June 11, 2025

**ADDENDUM #3
BID NUMBER: 24-11**

ESPLANADE BUILDING 4 ELEVATOR ADDITION

SK-01

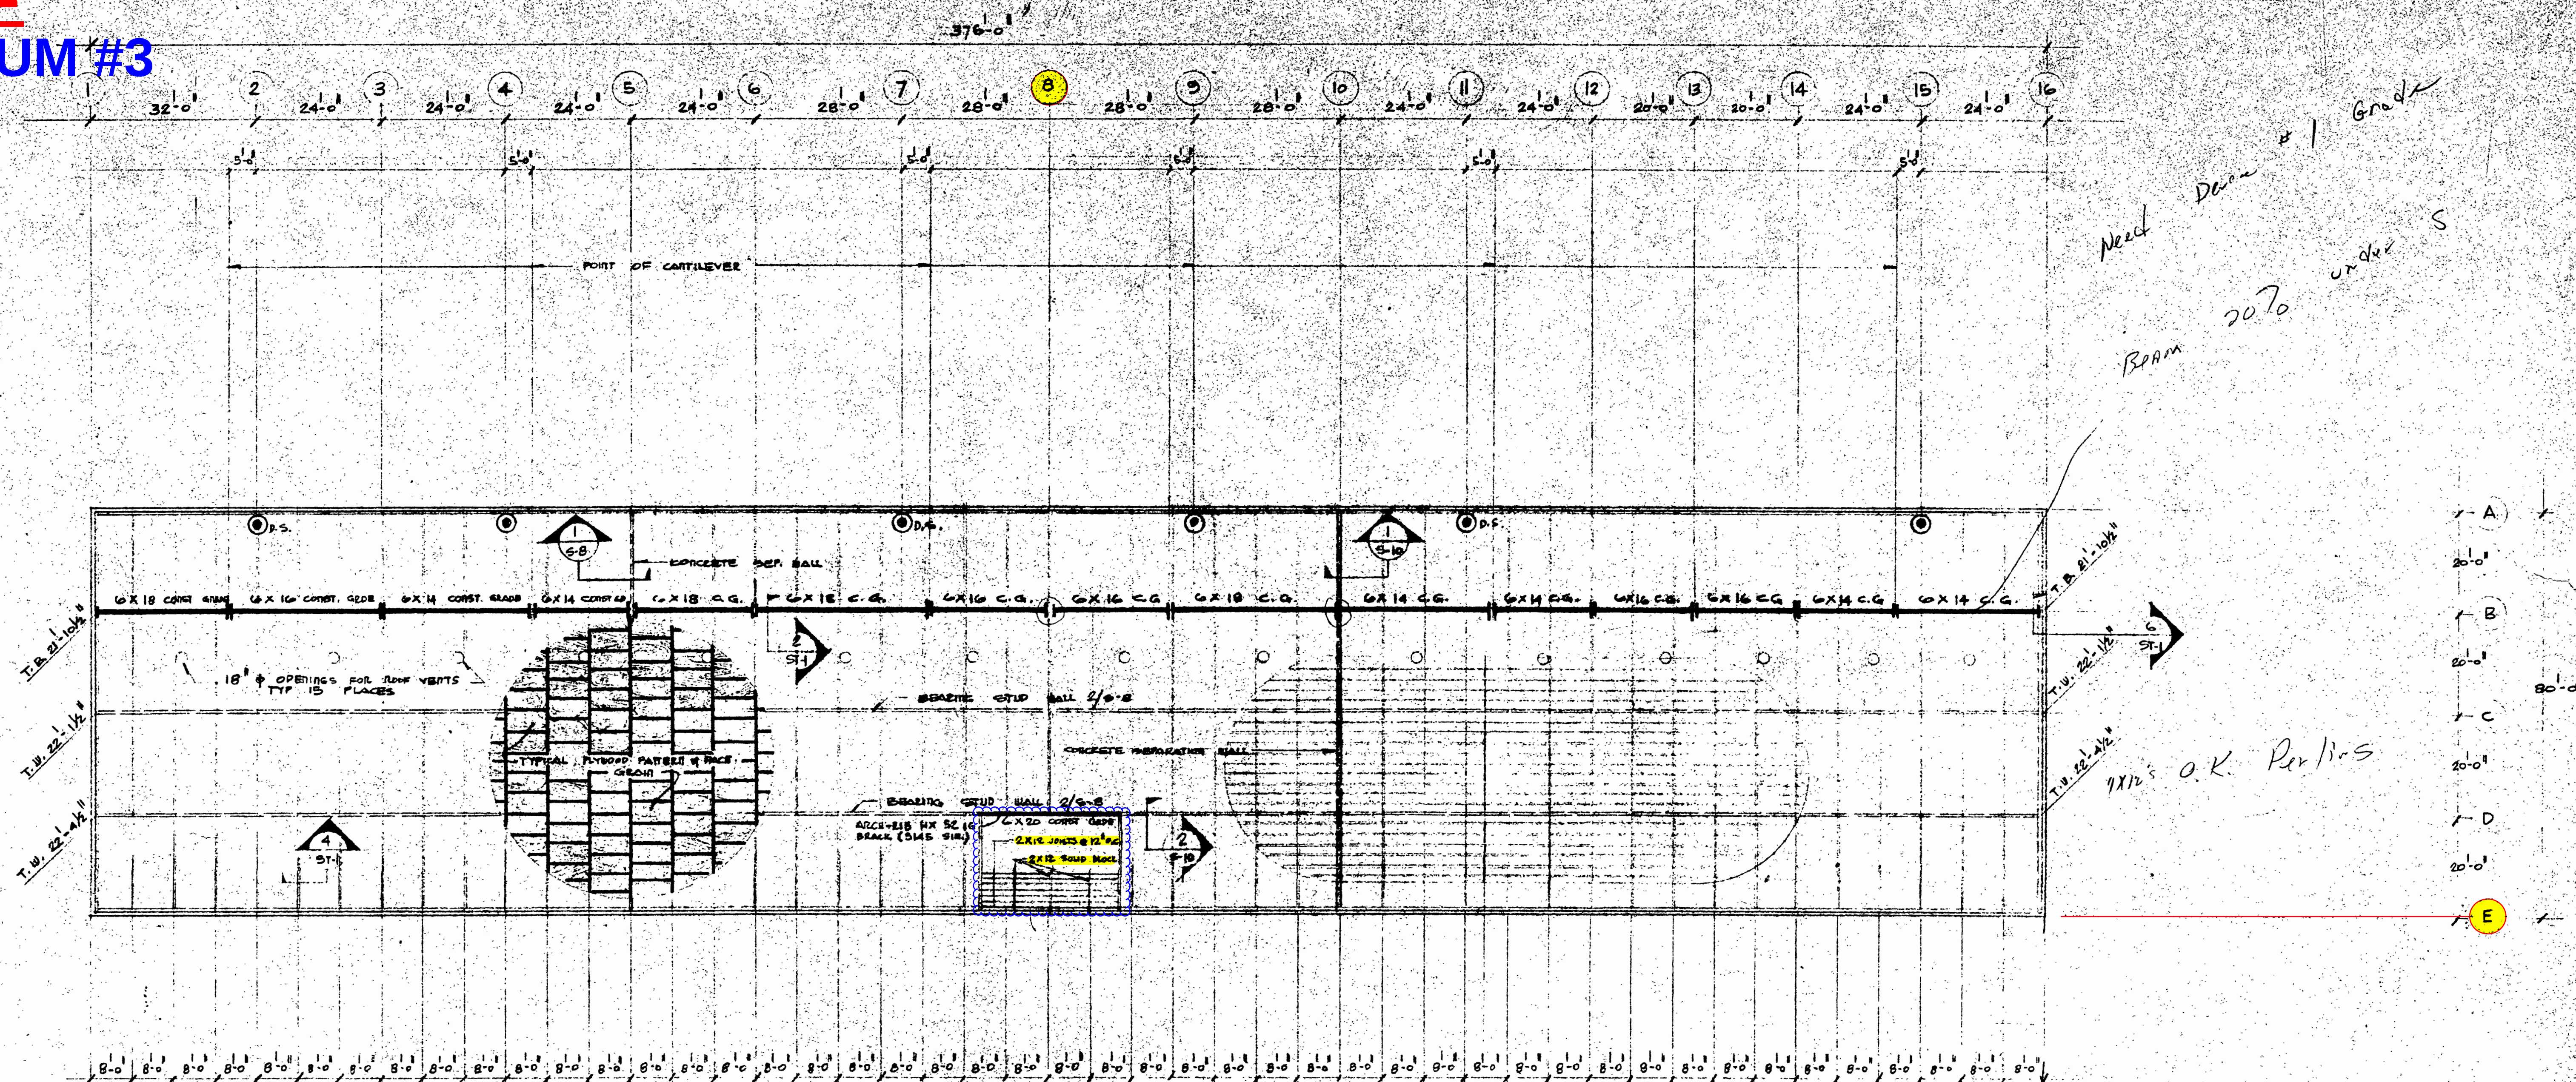
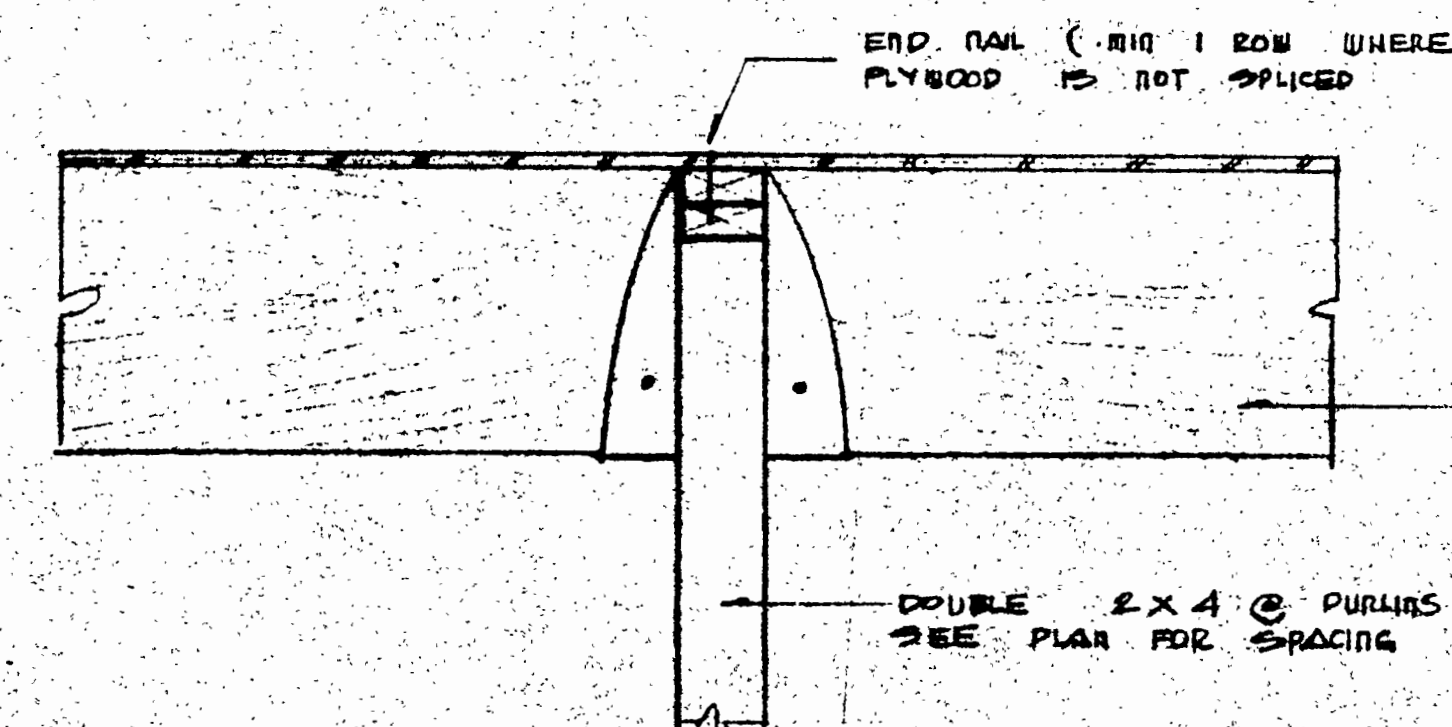
1. Question: We need additional clarification on the addendum #2 – question #3 response. See attached sketch for clarification.

- Response: Per as-builts, roof framing at lobby does not match surrounding structure & 4x12 purlins do not extend into lobby. 2x12 framing spans from North-South, wall to wall. See SK-01 and SK-02 for as-builts on following pages. Contractor to verify framing in field.

SK-02

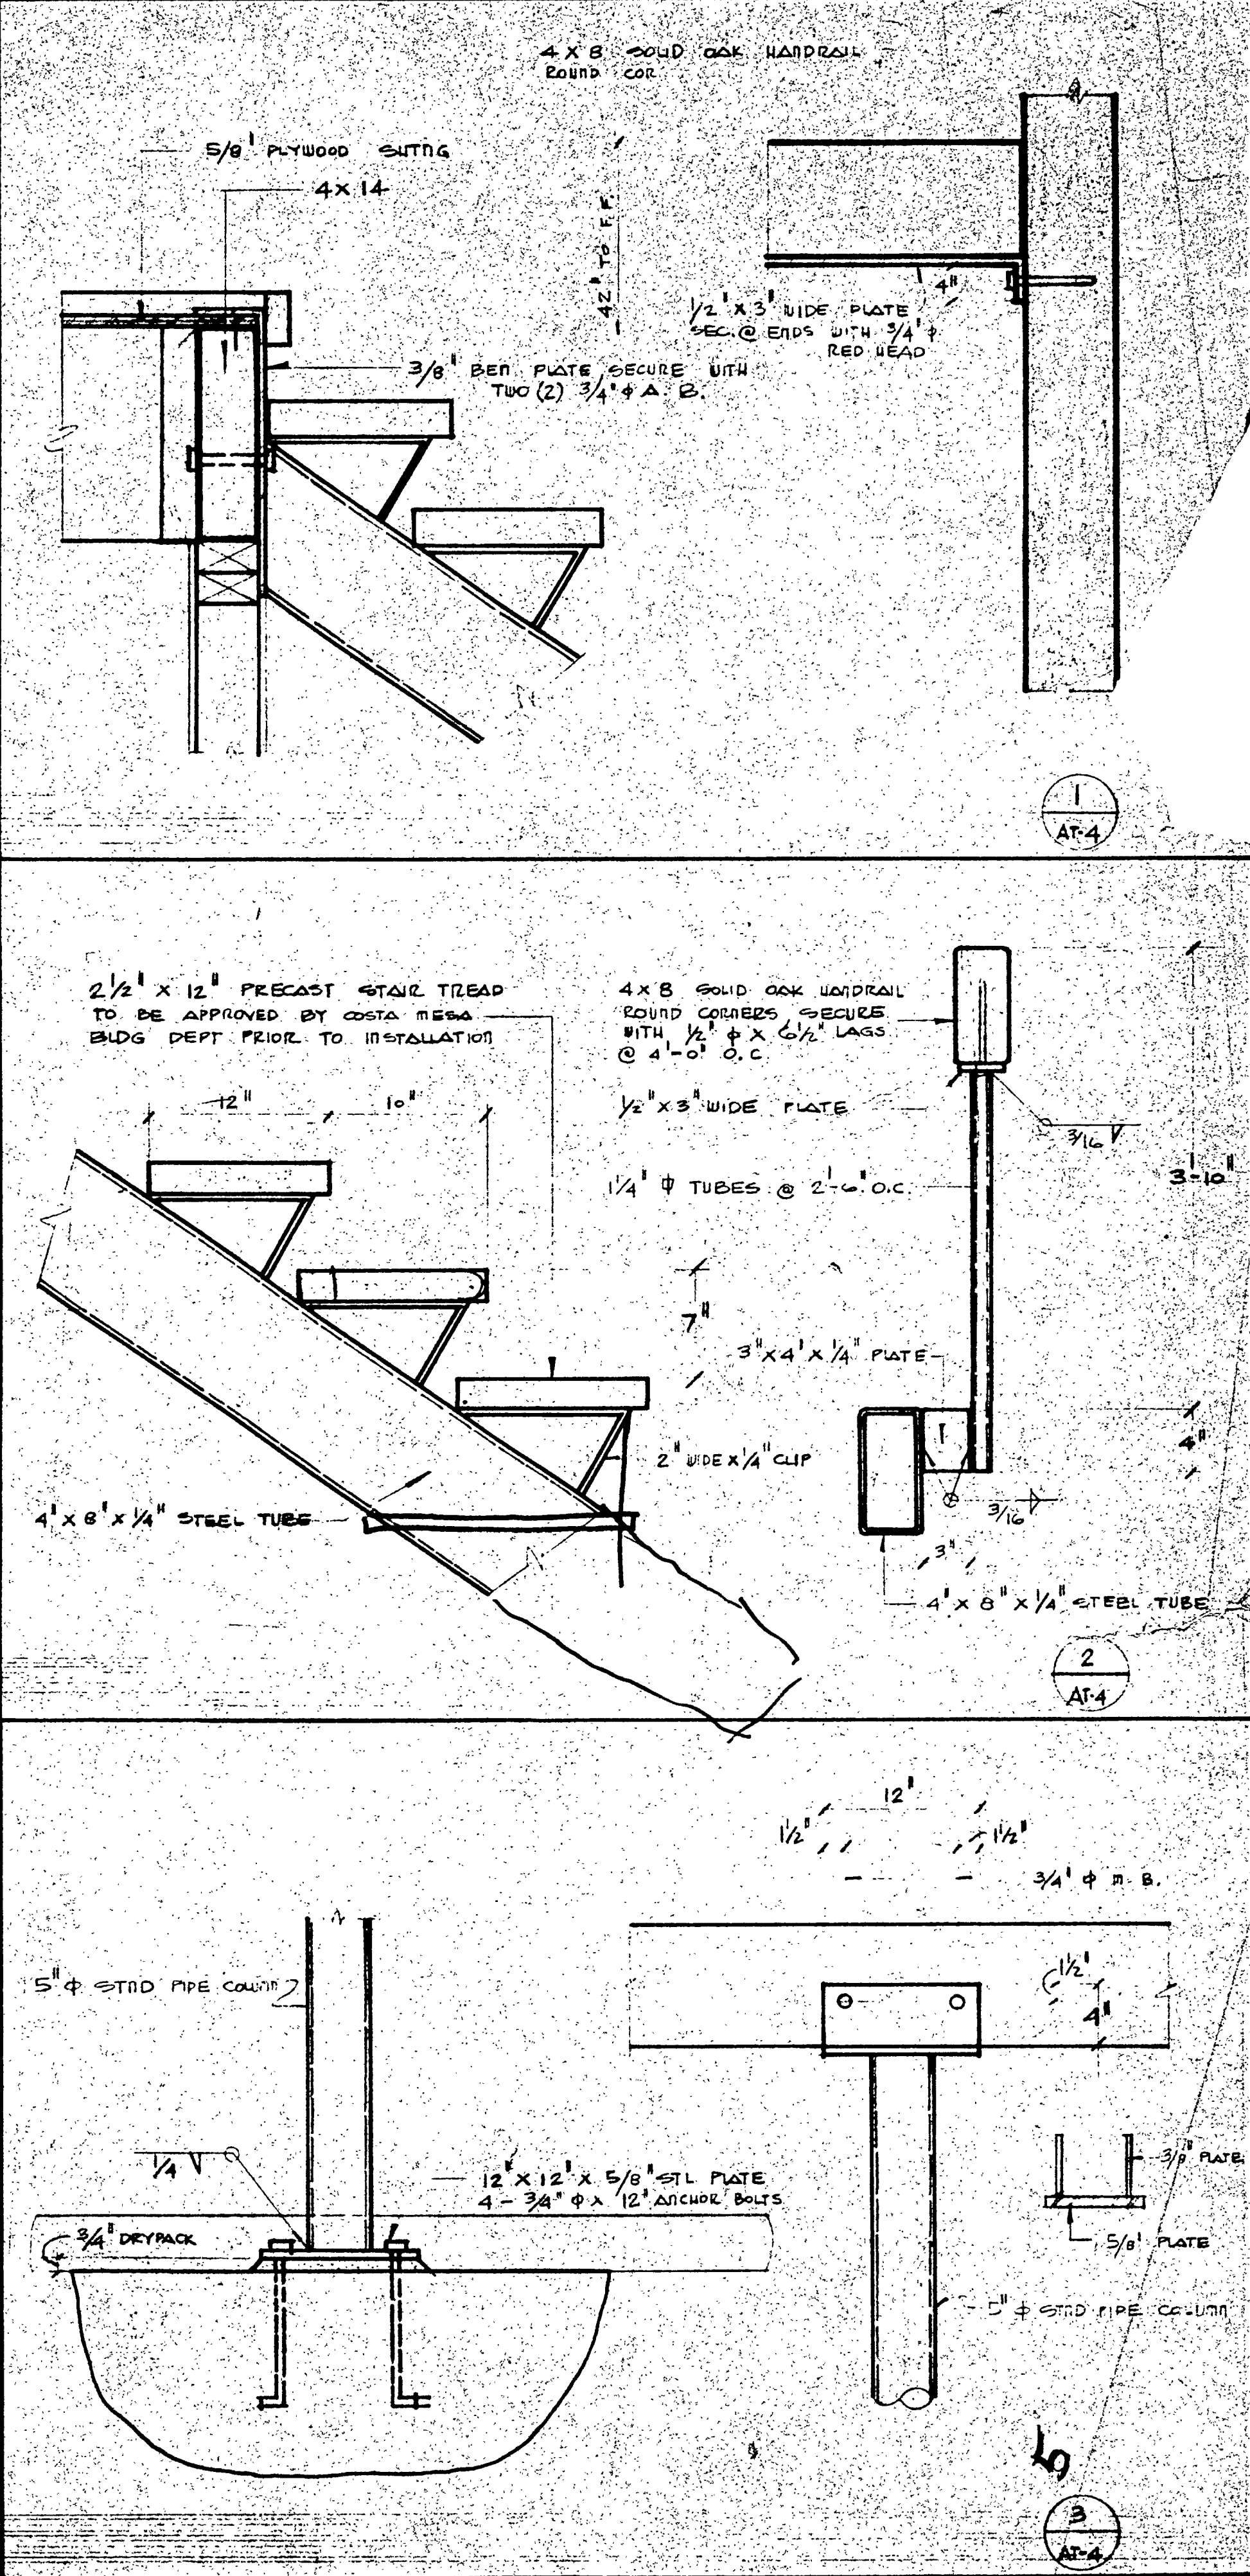
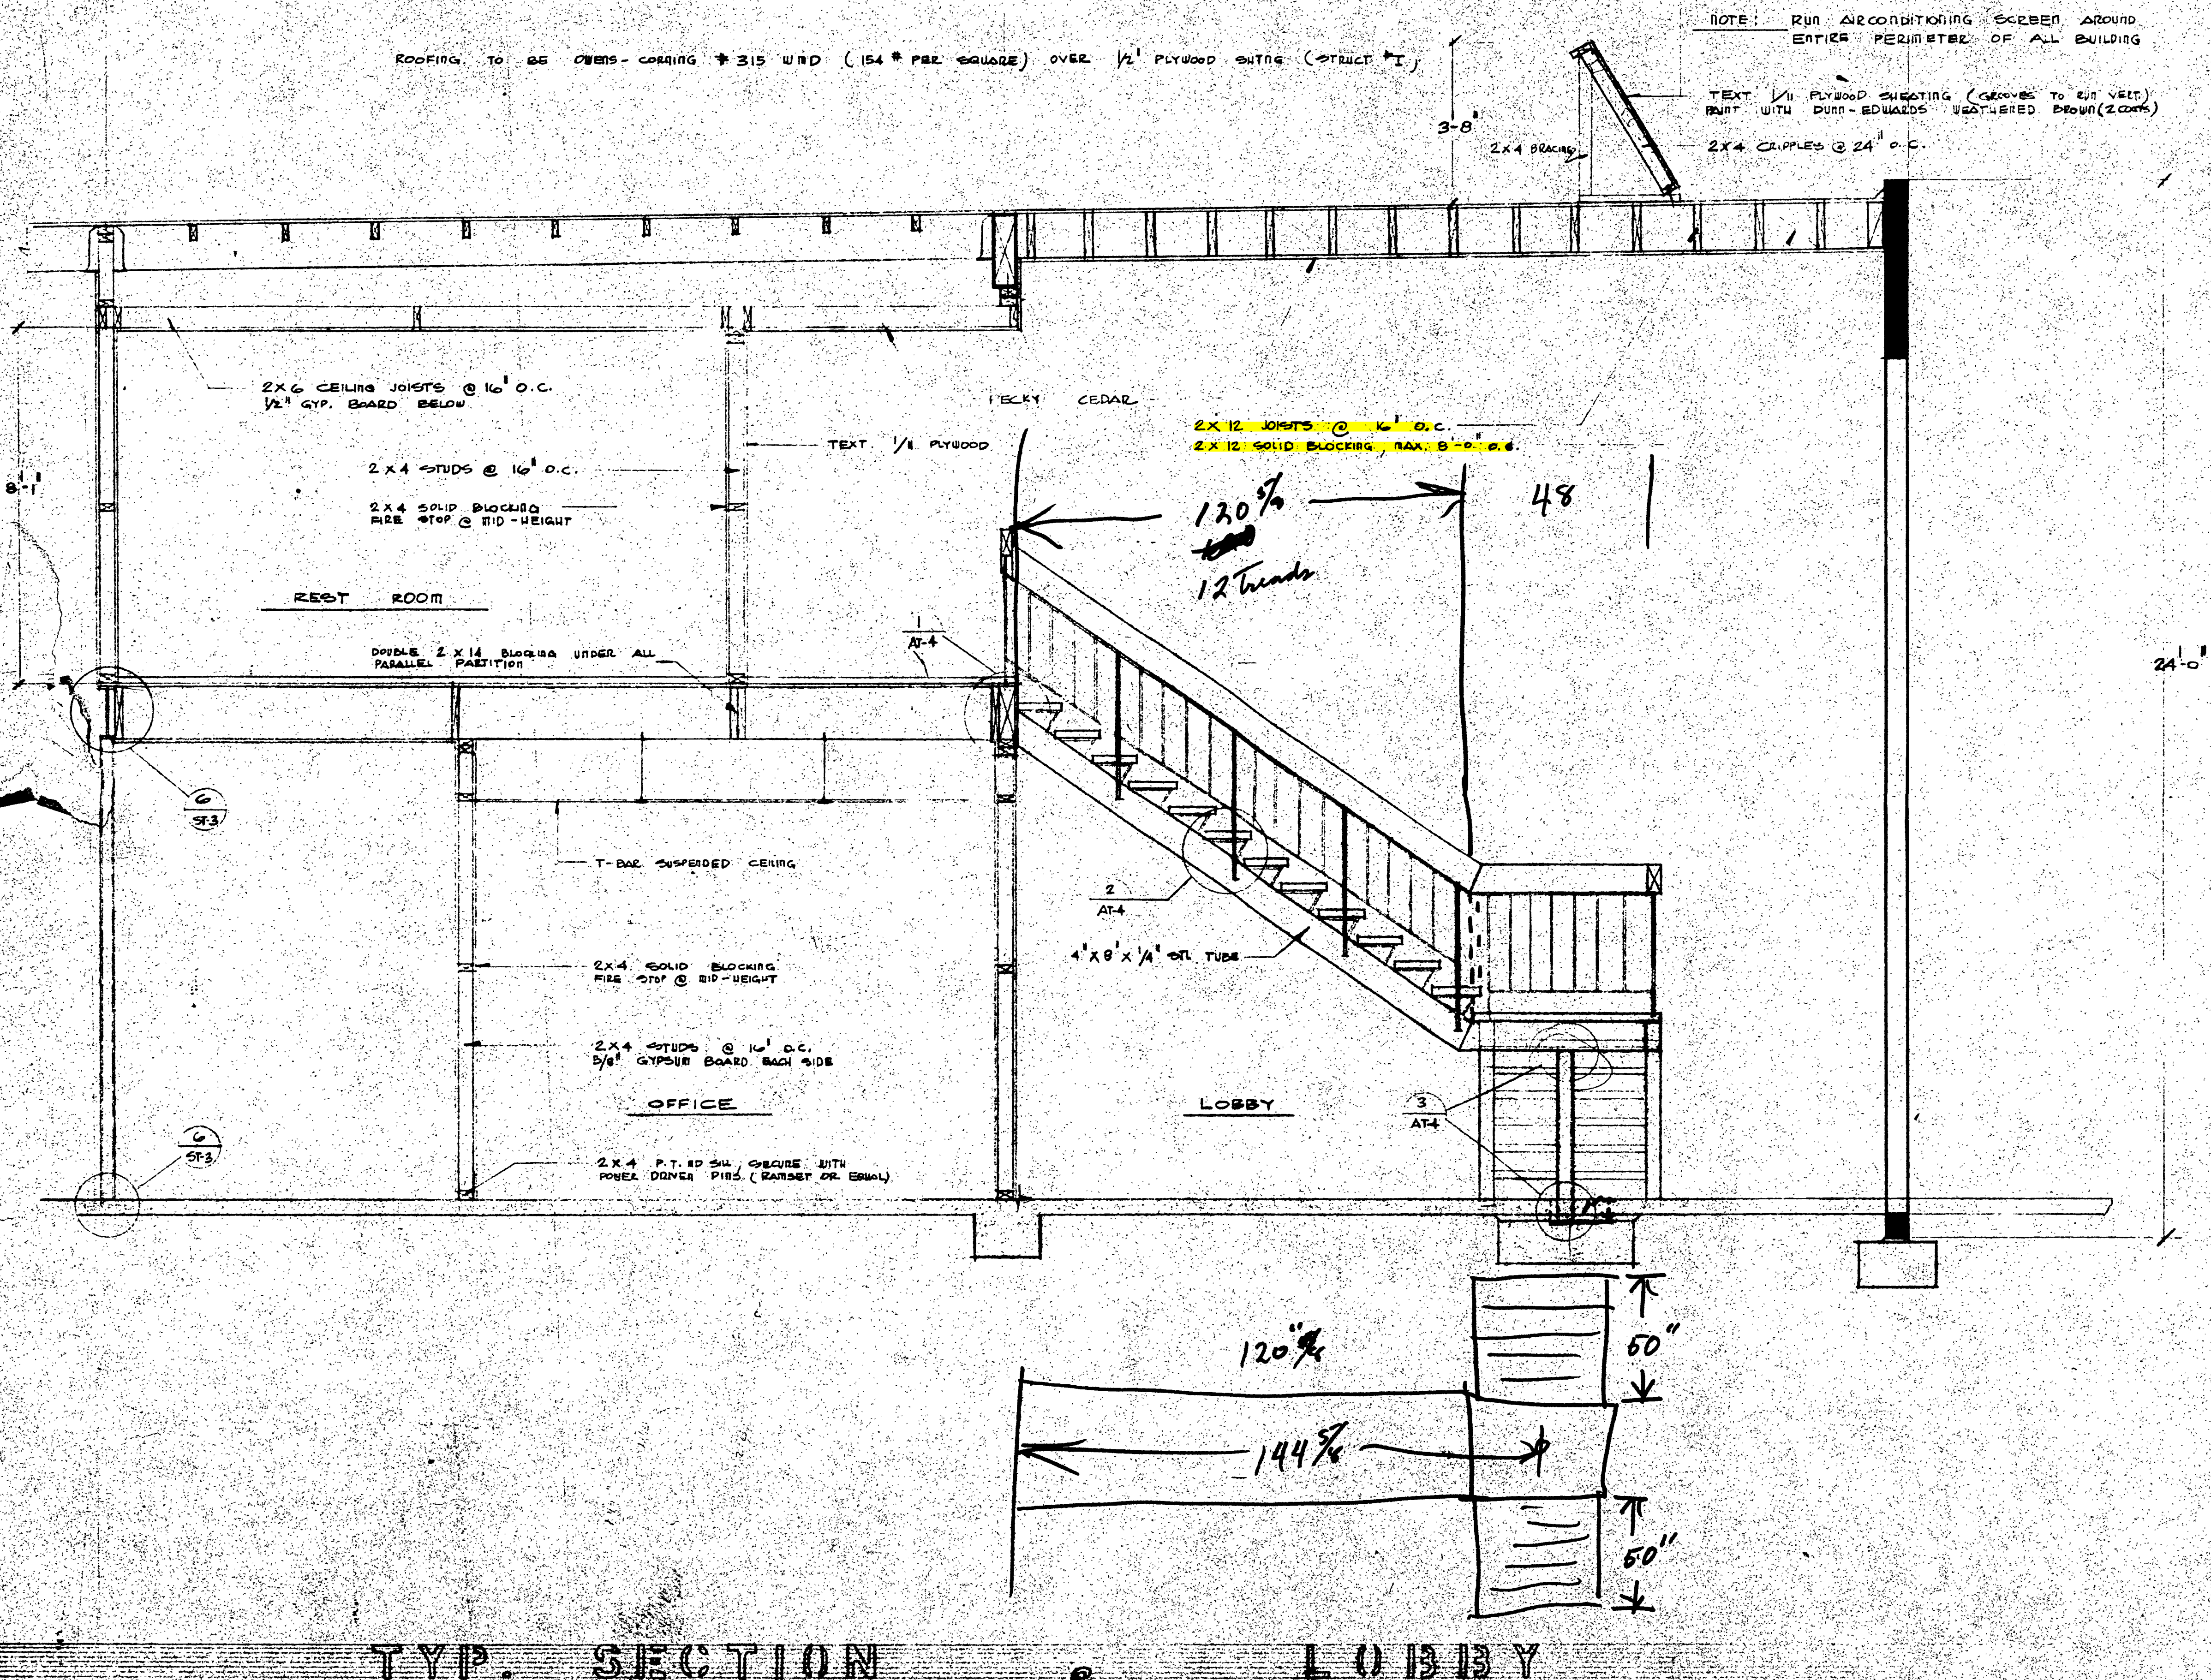
- Response: Keep (E) 2x12 framing in place as shown on plans.
3. Question: The existing 2x12 span between the 4x12 Purlins'. The plans shows the 2x12 spanning north to south which is correct, only they are between purlins not over purlins. The joist do not span east to west.

- Response: (E) 2x12s span wall to wall, (E) 4x12 purlins do not occur in lobby. See as-builts in following pages.
4. Question: Provide detail of how the 4x12 on grid 8 attaches to the new CMU shaft wall on the east and west side.
